Subject: Duke Energy Carolinas, LLC (Duke)
Catawba Nuclear Station, Units 1 and 2
Docket Numbers 50-413 and 50-414
Technical Specifications (TS) and/or Bases Sections:
3.3.2, Engineered Safety Feature Actuation System
(ESFAS) Instrumentation
3.3.3, Post Accident Monitoring (PAM) Instrumentation
3.5.4, Refueling Water Storage Tank (RWST)
3.6.6, Containment Spray System
License Amendment Request for Emergency Core Cooling
System (ECCS) Water Management Initiative

Pursuant to 10 CFR 50.90, Duke hereby requests a license amendment to revise the Unit 1 and Unit 2 TS and associated Bases to allow manual operation of the Containment Spray System and to revise the upper and lower limits on the RWST. Affected sections of the TS and/or Bases are:

Figure 1
CNS LOCA M&E Release
RSG Cold Leg Pump Discharge - Min ECCS Case

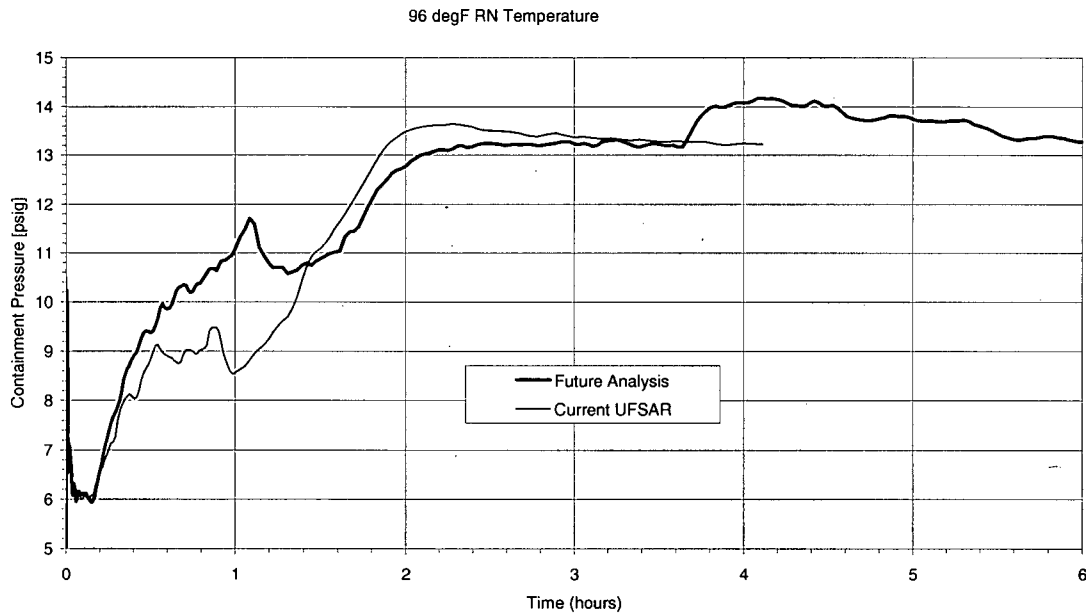
Two phenomena previously not included in Catawba peak containment pressure response analyses were observed. The first phenomenon, intact loop seal refilling, directly affects the peak containment pressure. The current containment analysis diverts flow from the RHR pump from the cold legs and core cooling, to be used as auxiliary containment spray. The reanalysis keeps this flow aligned to the cold legs. For a cold leg break, the core steaming rate decreases with decay heat. The majority of the steam generated in the core passes through the broken loop and is

released to containment. A fraction of this steam is drawn through the intact loops by the condensation of steam by cooler ECCS injection. Eventually the steam velocity in the intact legs decreases to the point where liquid spills over the reactor coolant pump weirs and refills the intact loop seals. At this point in time, all of the steam generated in the core exits the broken loop into containment to be condensed. In Figure 1 shown below, this occurs just after 3.5 hours.

The second phenomenon observed is a significant increase in the amount of reverse break flow. This is steam predicted to be drawn from containment into the RCS by steam condensed on subcooled ECCS injection. The Duke containment response methodology is an iterative method that uses GOTHIC for the containment response calculation and RELAP5 for the mass and energy release calculation. Steam predicted to be drawn from containment into the RCS in the RELAP5 calculation is not removed from the GOTHIC calculation. This steam flow is non-conserved mass and energy. In the present containment response calculation, the predicted reverse break flow is a penalty incorporated in the results. For the reanalysis, the magnitude of this penalty is such that it was desirable to mitigate this flow. The ECCS steam condensation rate in the cold legs is mitigated by the inclusion of nitrogen in the RELAP5 containment boundary condition. This change reduced the magnitude of the reverse break flow penalty.

Figure 2

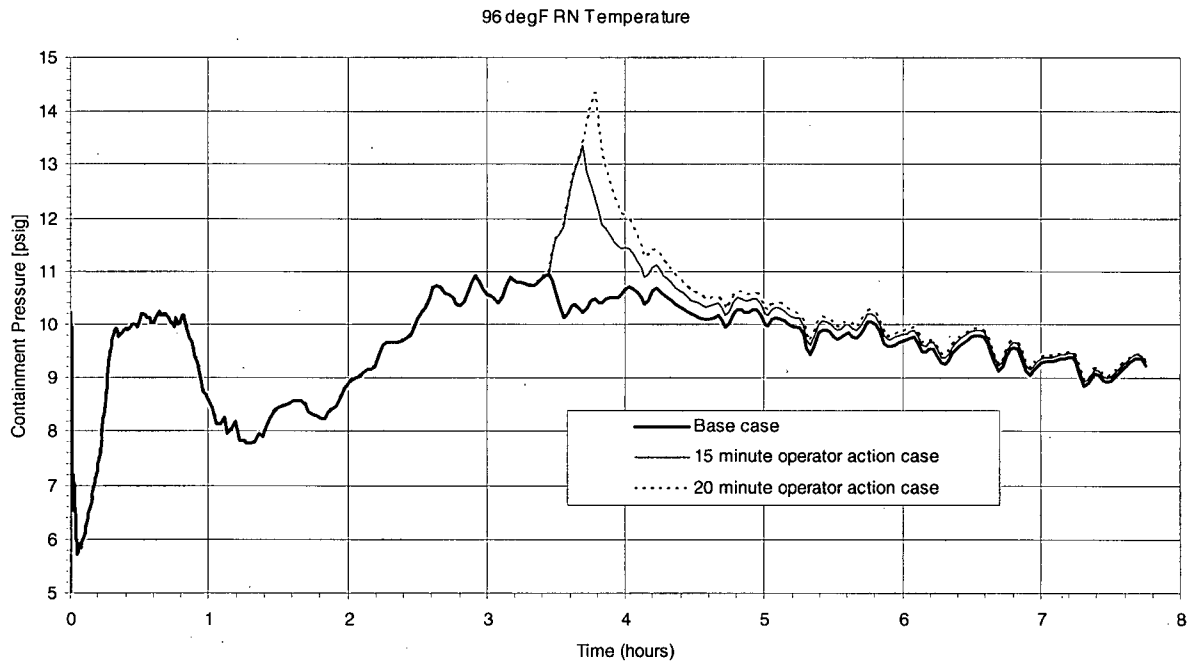
A sensitivity study has been performed to evaluate the containment pressure response to a containment spray pump run failure. The pump is assumed to fail at the time of peak pressure for the event. The results of this sensitivity study, shown on Figure 2, indicate that 20 minutes are available for operator action to initiate containment spray flow from the idle spray pump. If containment spray flow is initiated within 20 minutes, the peak containment pressure will remain below the containment design pressure. Operator action is reasonably achievable within the 20 minute timeframe.

Figure 3
Catawba LBLOCA Sump pH Response
Water Management

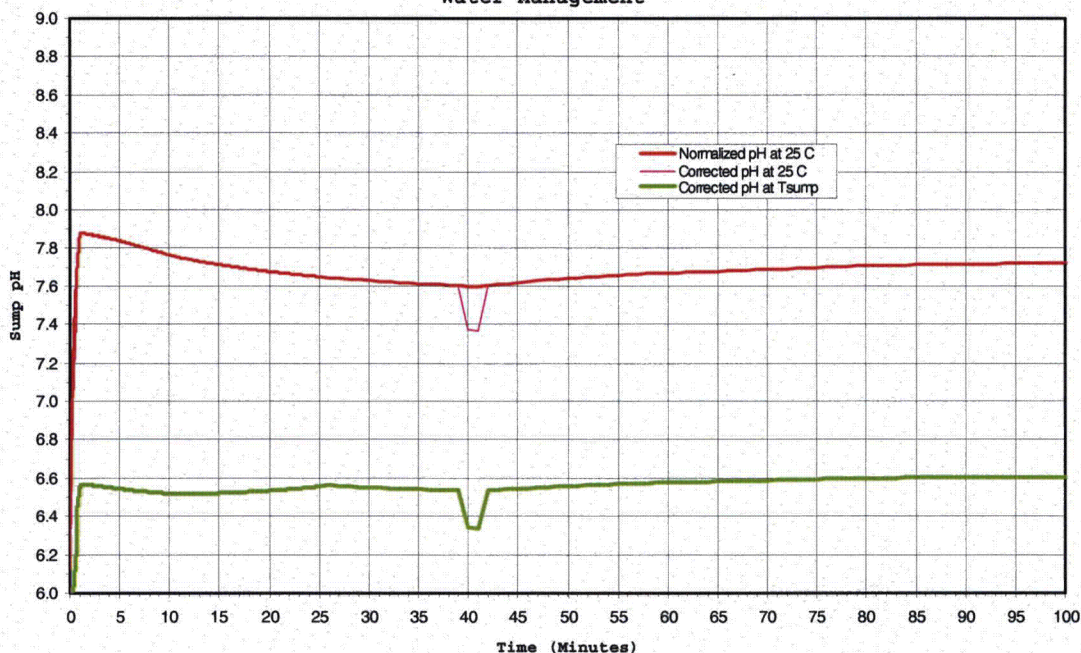
Post-LOCA containment sump pH was calculated with the proposed modifications assumed to be in place. The method of this calculation was unchanged from the current licensing basis (Ref. 1, 2, 5). The water inventory of the RWST was set to its upper bound value adjusted only for the elevation of the outlet piping. In particular, no flow from the Containment Spray System was simulated. Flow from the ECCS was used to simulate the transport of boric acid solution from the RWST to the containment sump. The Containment Spray System will not take suction from the RWST with the proposed modifications. All other input to the calculation of post-LOCA containment sump pH remained unchanged from the current licensing basis (Ref. 1, 2).

The post-LOCA containment sump pH with the proposed modifications is shown in Figure 3. The short term containment sump pH increased somewhat with the proposed modifications. The results showed a very small decrease in the long term post-LOCA containment sump pH. The minimum transient containment sump pH was found to be 7.4 at the reference temperature of 77°F (25°C). The current minimum transient containment sump pH is 7.2 (Ref. 1, 2). The lower bound value for the equilibrium sump pH was found to remain essentially unchanged at 7.7 at 77°F (25°C). With the proposed modifications, the post-LOCA containment sump pH remains above 7 at 77°F (25°C) at all times. Containment sump pH also was calculated at the temperature of the water in the containment sump. This yielded a minimum transient sump pH of 6.3 (up from 6.2) and a lower bound equilibrium pH of 6.6 (not significantly changed from the current licensing basis value).
